Office Action Summary

10/777,756

OGIWARA, RYU

DETAILED OFFICE ACTION

FIG. 5

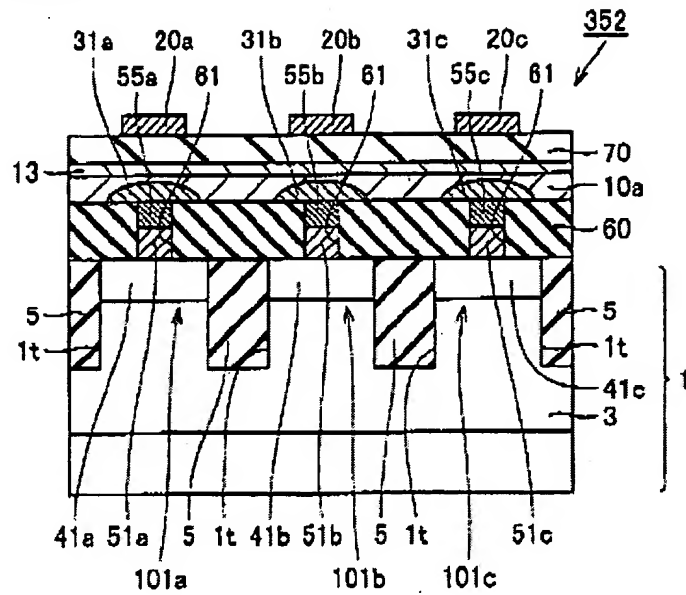
Kuge discloses (in the title, fig 2,fig 5, fig 11,column 1 lines 16-25) a phase-change memory device comprising: memory cells (fig 1 reference 31a) including phase-change layers formed on a semiconductor substrate, the phase-change layer showing an amorphous-crystalline phase change; a memory cell array which has the memory cells arranged in a matrix, the phase change layer including first regions (fig 2 layer 3) which contact the semiconductor substrate in units of memory cells and a second region (fig 2 layer 41a) which connects the first regions arranged in a same column; a first electrode layer (fig 2 layer 10a) formed on the second

FIG. 11

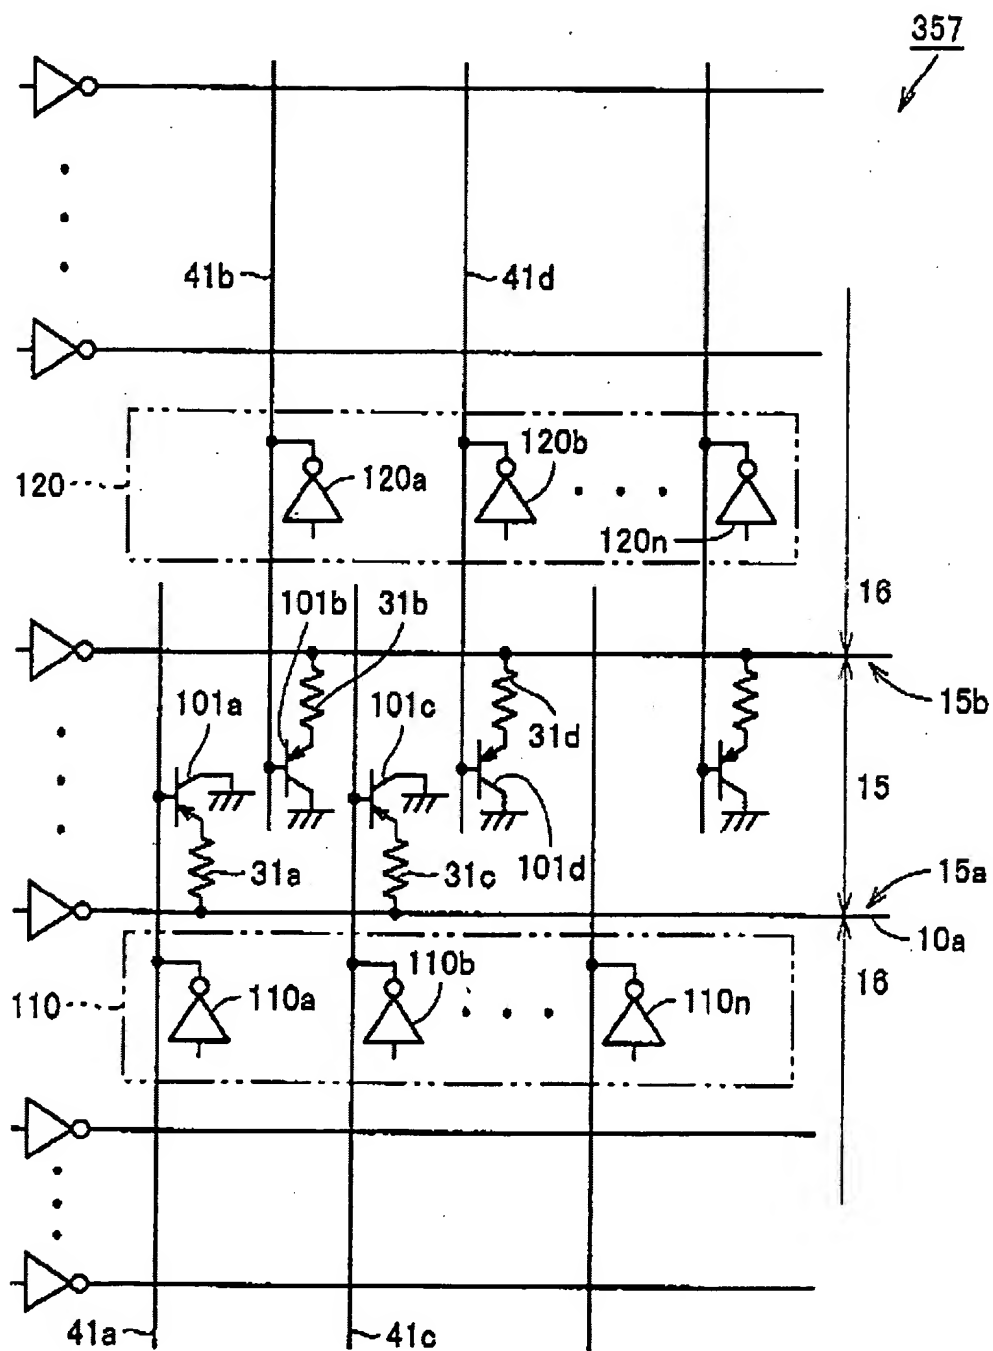
Kuge (fig 11) discloses a phase change memory device wherein each memory cell includes a bipolar transistor formed in the semiconductor substrate, a collector or an emitter of the bipolar transistor being connected to a corresponding one of the first regions, a base of the bipolar transistor being connected to the word line (fig 11 line 41a).

FIG. 1

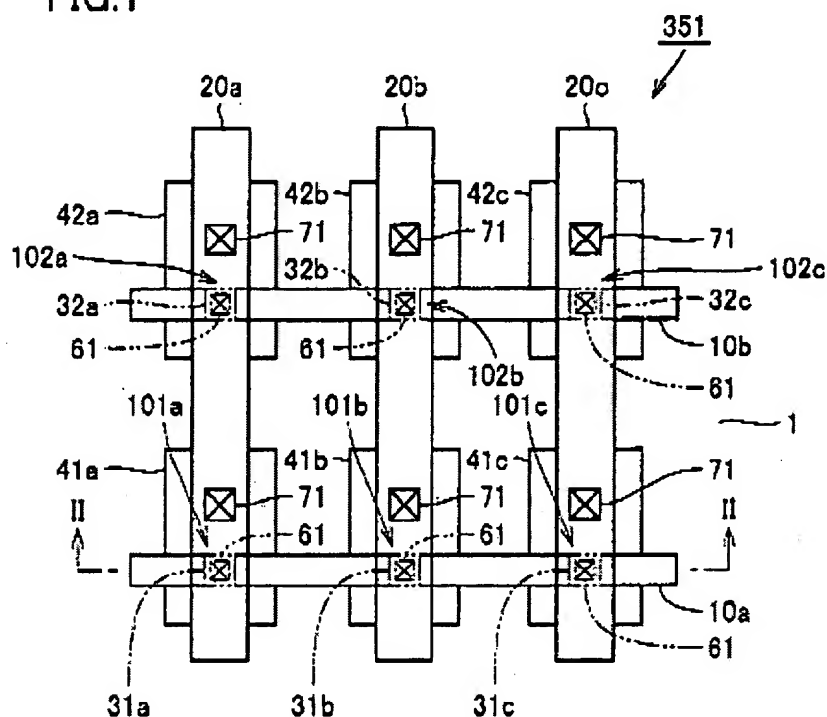
Kuge (fig 1,fig 11) discloses a phase change memory device comprising a contact plug, which connects the first electrode layer and the bit line (fig 1 contact hole 61 bit line 10a).

Kuge (fig 1, column 1 lines 16-25, column 5 lines 5-7) discloses a phase change memory device comprising the second region of each phase-change layer is in a crystalline state, and at least part of each first region of each phase-change layer assumes one of the crystalline state and an amorphous state in accordance with write data.

Noted that even though Kuge does not mentioned that layer 10a is polycrystalline; layer 10a is inherently in polycrystalline state since it is a chalcogenide contact layer while storage layer 31a can change phase from polycrystalline to amorphous.

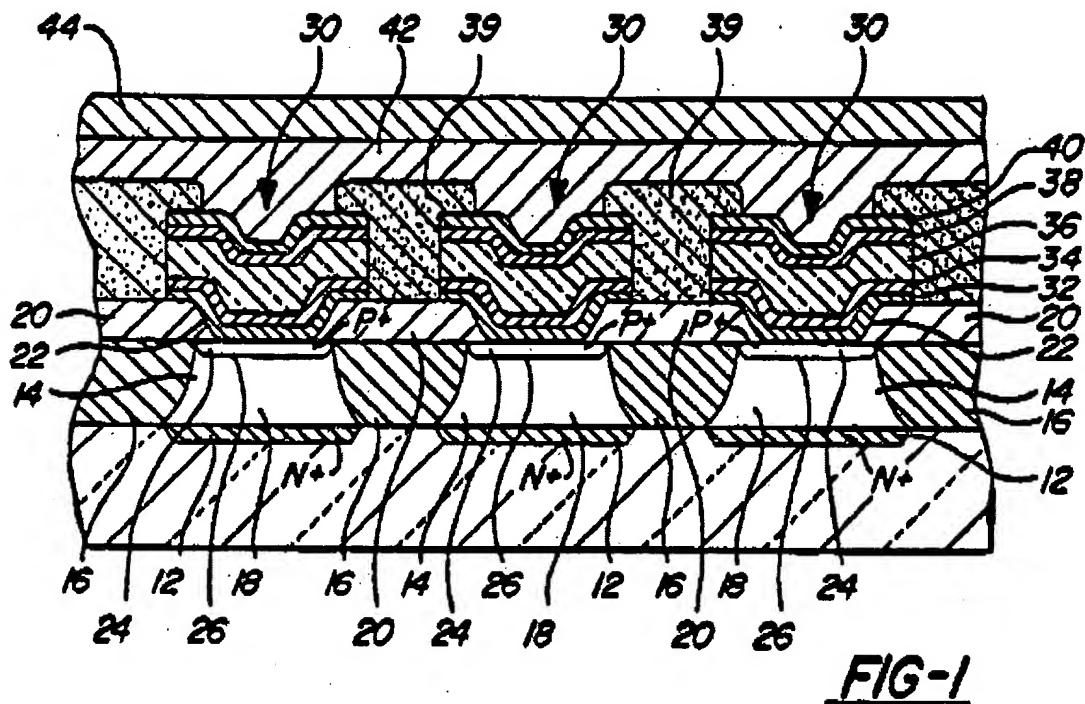
As discussed in the rejection of claim 3 the combined teachings by Kuge and Klersy disclosed all the invention of claim 6 except for an electrode layer in which the interface surface with the cell storage region is smaller than the interface surface opposing this layer. Ovshinsky, however, discloses a electrode layer (fig 1 layer 24) in which the interface surface with the cell storage region is smaller than the interface surface opposing this layer.

FIG. 2

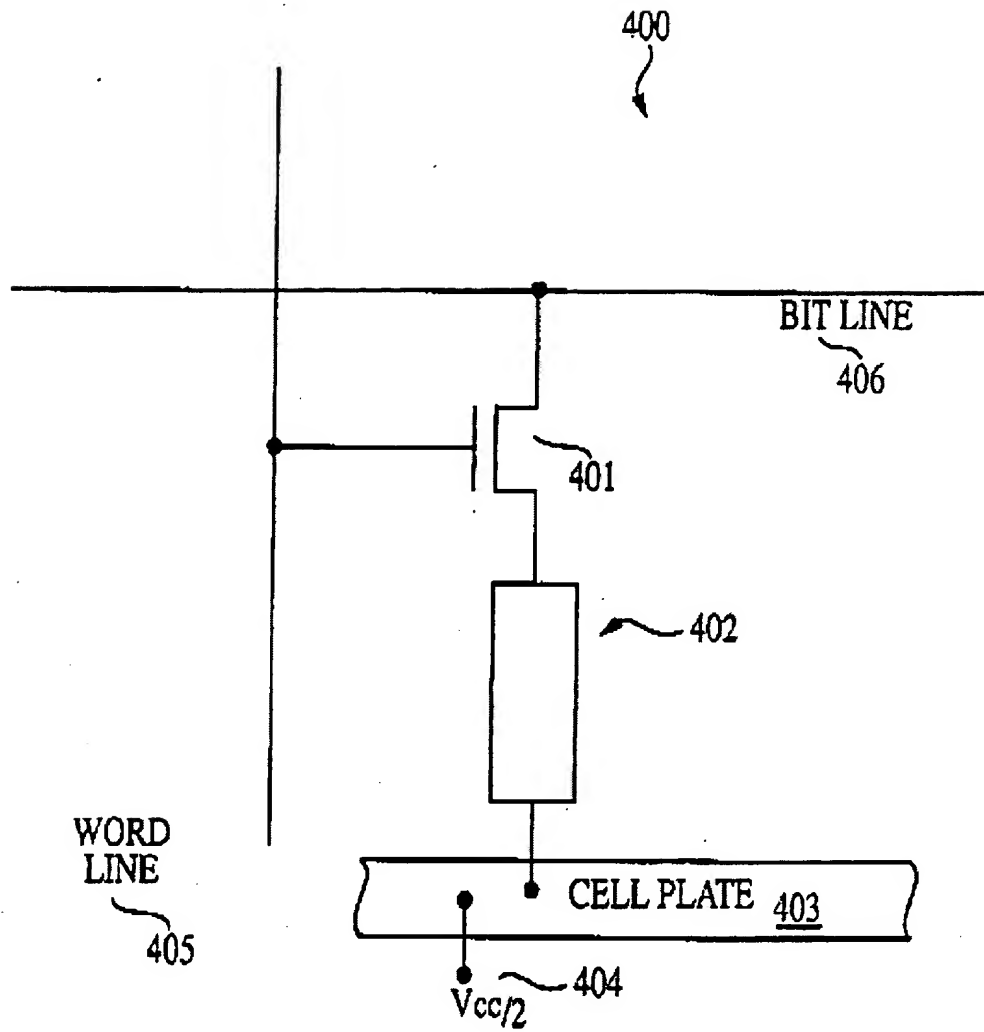
Kuge discloses all the invention except for using a MOSFET switching element. Hush, however, (fig 2) discloses the use of a MOSFET switching element for a phase change memory device.

a person skilled in the art at the time the invention was made would have been motivated to use an alternative of Bipolar Junction Transistor Switch by a MOSFET switch as taught by Hush to improve the device by Kuge since MOSFET are known in the art as consume less power than BJT.
